HISTORIC DISTRICT COMMISSION

6:30 p.m. April 3, 2024

- A. Certificate of Appropriateness Application: **207 W. Queen Street** – Applicant is requesting to replace an existing chain-link fence with a black aluminum picket fence that encloses the back yard. (PIN 9874176601)

- A. Certificate of Appropriateness Application: **114 W. Queen Street** – Applicant is proposing to add porches to the main house, construct a detached accessory dwelling unit to the northwest of the existing Strudwick kitchen structure, and construct two sheds in the northeast corner of the property (PIN 9874071780)

North Elevation

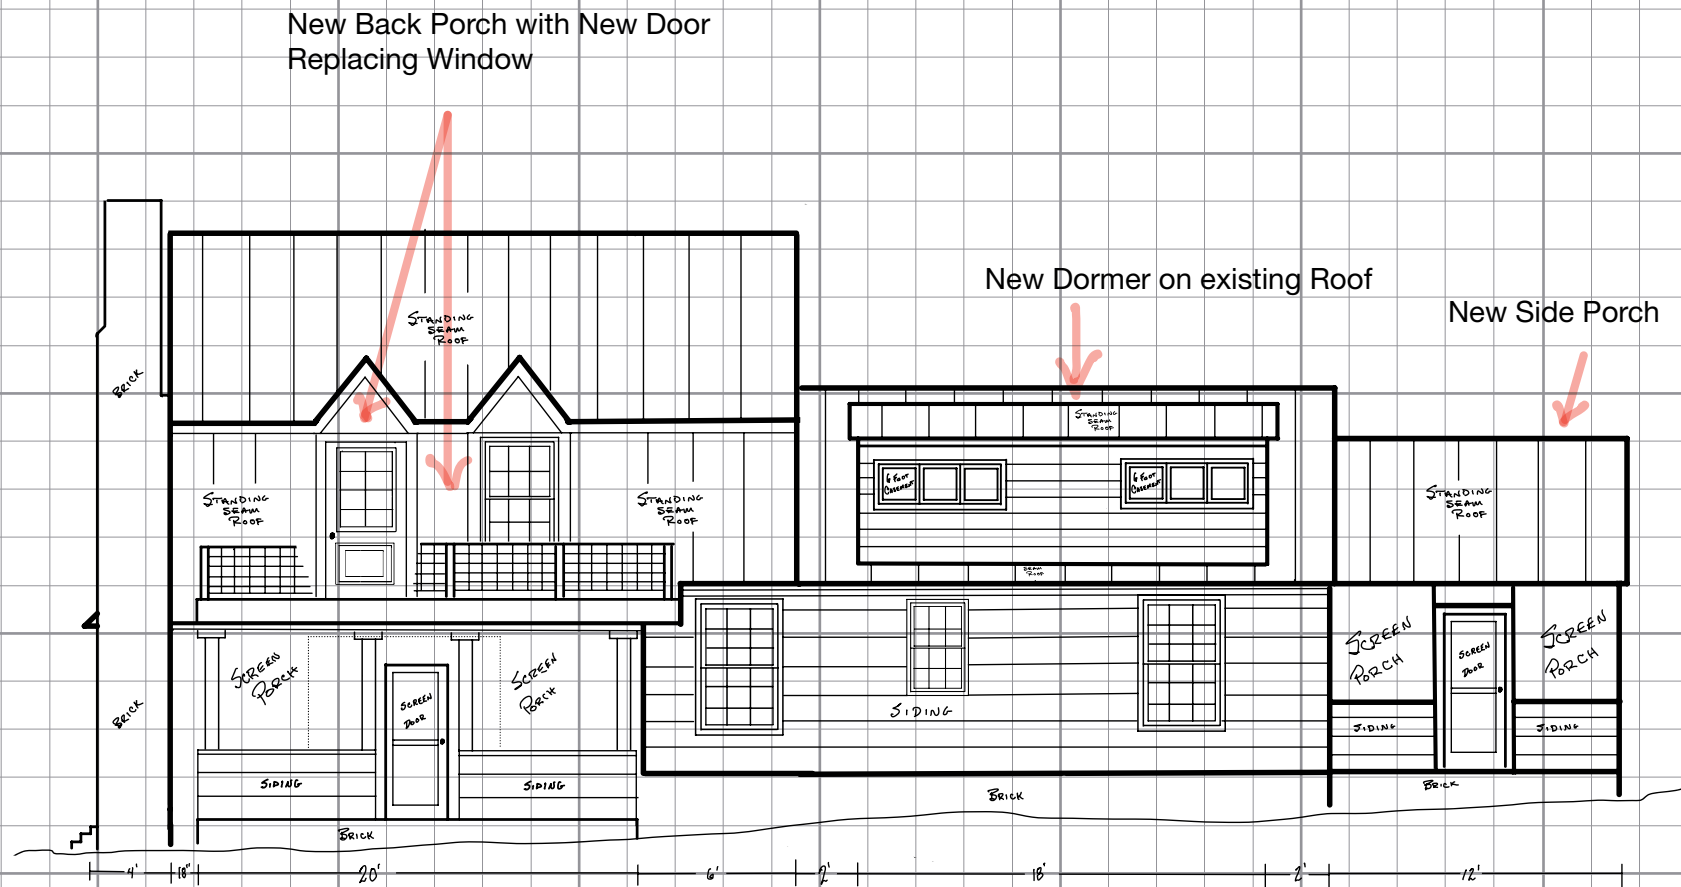
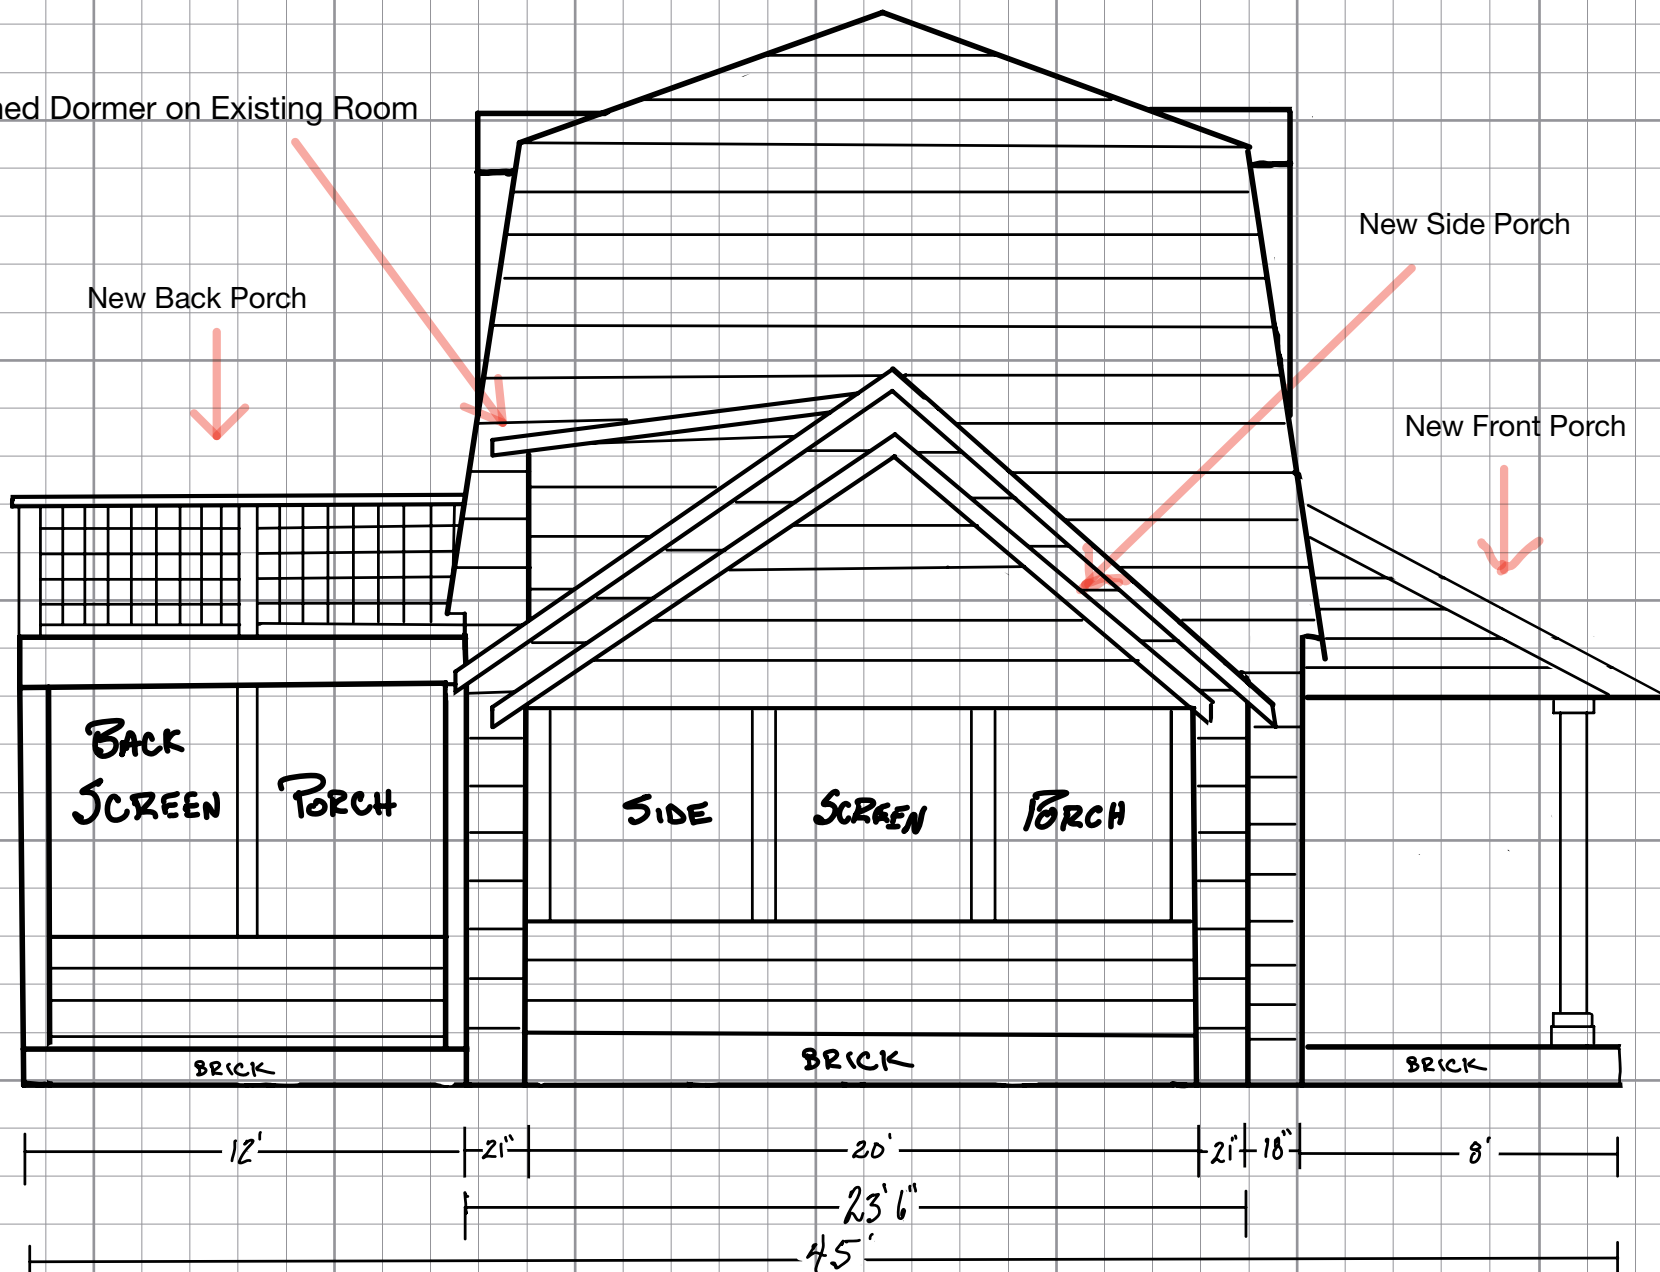
- The applicant has submitted updated elevations and an updated site plan for the alterations to the existing house. The alterations are indicated by colored arrows in the elevations and blue on the footprint. The most noticeable change from the initial submission is that both screened porches now have screens on all three exterior sides.
